Space House

Planning Condition Discharge Report

Conditions 3LBC c)

For Seaforth Land

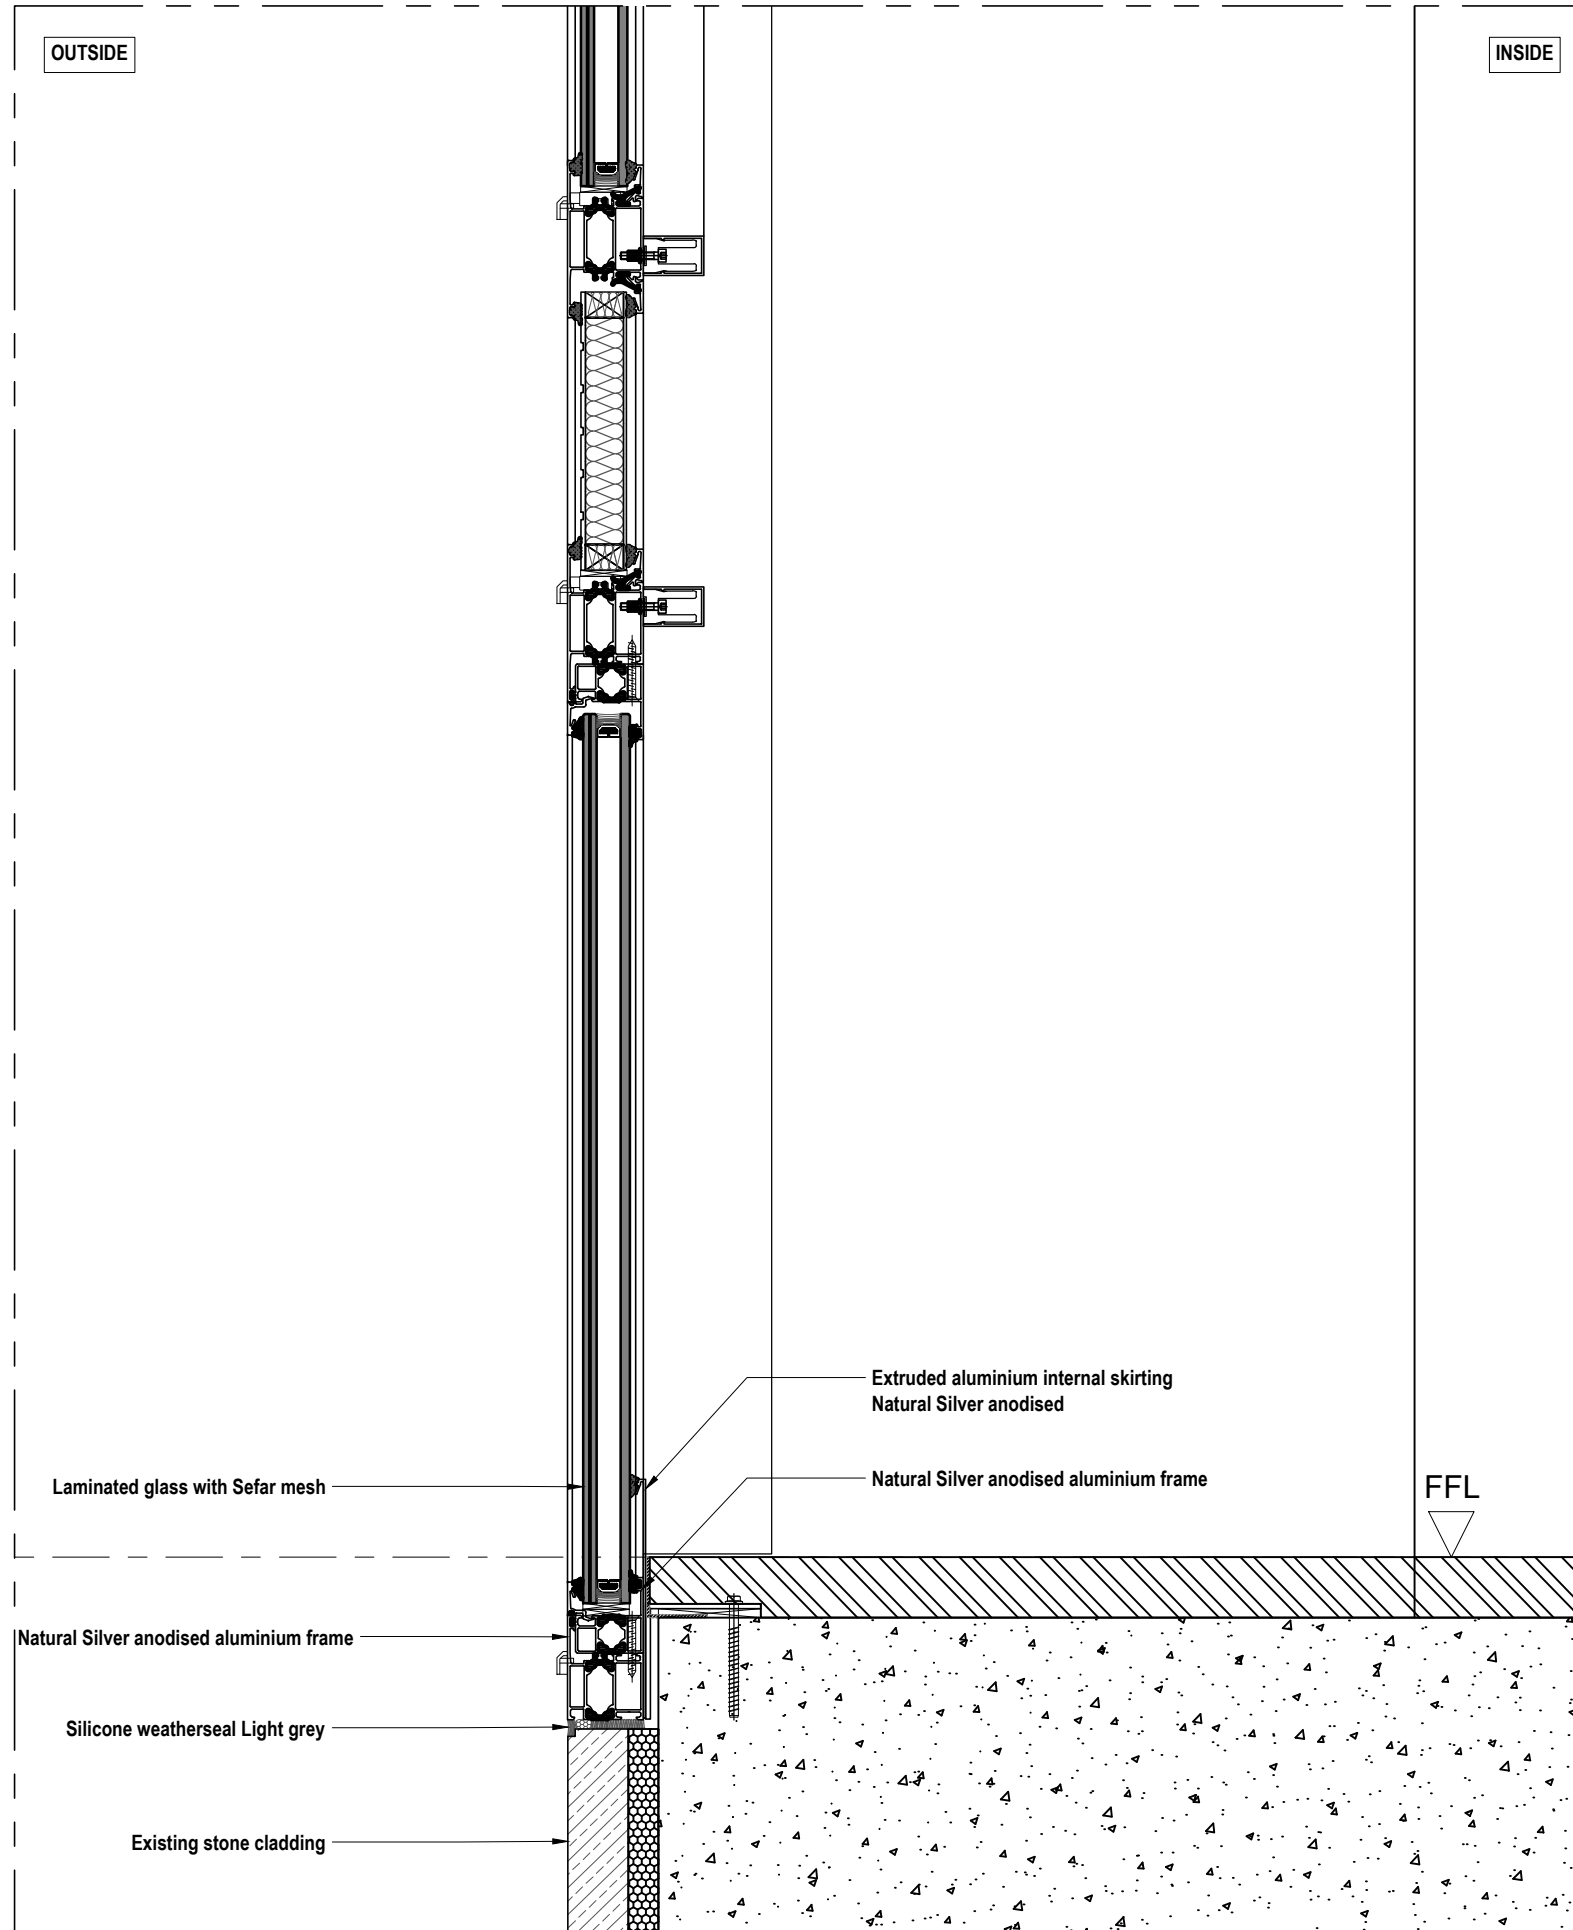
14616-CLL-KW-ZZ-DR-X-20101 and 14616-CLL-KW-ZZ-DR-X-20103 previously consented under 3LBC c) condition have been updated and upreved to capture the changes described above. The Kingsway staircore window detail drawing 14616-CLL-KW-ZZ-DR-X-25001 also previously approved under condition 3LBC c) remains unchanged and is not affected by the proposed changes to the typical office plate window units (fixed and openable).
